Summary of Items Discussed in 5/2017 APSEC Discussion Forum on 17 November 2017

NOTE :
U FOR LOW ZONE DEMONSTRATION

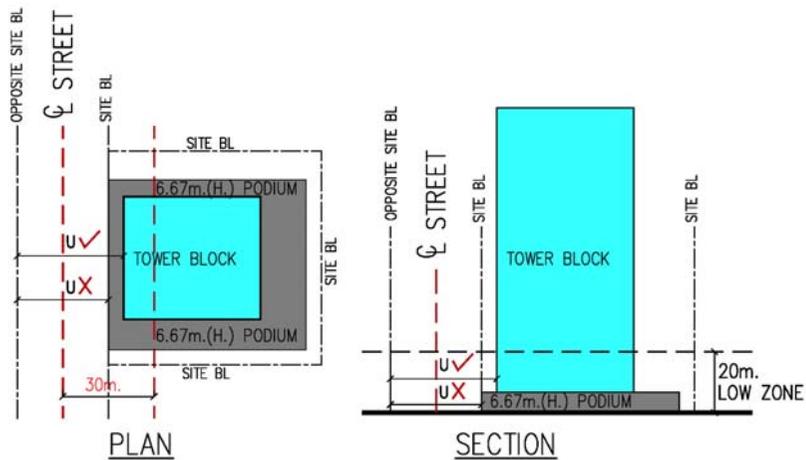
Items proposed by Convenors for Discussion	Summary of Discussion and BD's Responses
	Items raised by HKIA	
1	<p><u>Sustainable Building Design Guidelines</u></p> <p>Regarding Design Requirement (1) of Building Separation, the maximum permissible Lp of a building is obtained by multiplying 5 and the U on which the building abuts, where the U of such a street canyon in the assessment zone is measured perpendicular to the centre-line of the street <i>from the external wall of the building</i> that is within 30m from the centre-line of the street, to the site boundary of the other site on the opposite side of the street (Para.2.2, Appendix B of PNAP APP-152 refers).</p> <p>Para. 2.4, Appendix B of PNAP APP-152 further states that for the purpose of measuring Lp of a building along its long side, the part of the building that is <i>within the low zone and of a height of not more than 6.67m</i> may be disregarded.</p> <p>Based on the above, it is logical to deduce that the portion of the building that is within the low zone and of a height of not more than 6.67m should also be disregarded for the sake of deriving U at low zone. In other words, the U at low zone of such a street canyon is to be measured from the external wall of that portion of the building which is above 6.67m high as per the following diagrams. Please advise if our understanding is correct.</p>	<p>(Item withdrawn by HKIA during meeting.)</p>

SECTION FOR HOARDING BOARD WITH CATCH FAN

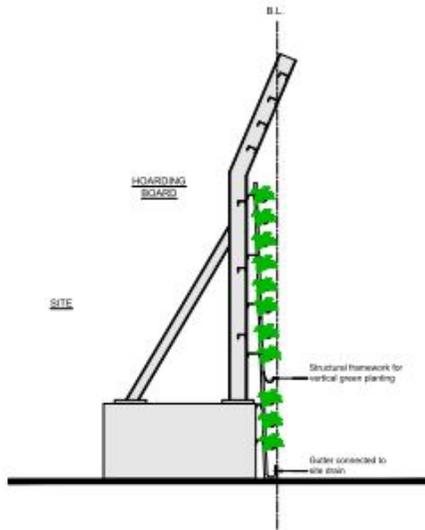
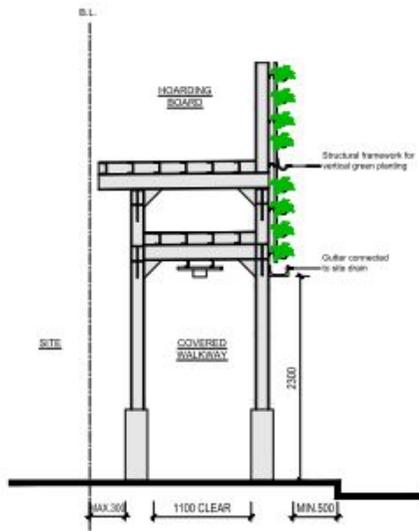
4	<p><u>Vertical Greening at Hoarding and Covered Walkway</u></p> <p>Referring to item 5 of ADF held on 8 August 2014, we would like to enquire whether BD will re-consider accepting vertical greening (VG) at hoarding and covered walkway to enhance the environment near construction site, provided that:</p> <ul style="list-style-type: none"> (i) Water supply and drainage of VG are properly designed; (ii) Structural calculation of VG is submitted; and (iii) Relevant requirements of TD/ HyD set out at Appendix A of PNAP APP-23 are complied with. 	<p>BD welcomed the proposal and reiterated item 5 of the said ADF that a number of factors had to be considered to ensure safety and avoidance of creating nuisance and inconvenience to the public. In particular, comments from other relevant departments and the proper maintenance of the vertical greening should be observed.</p>
---	---	--
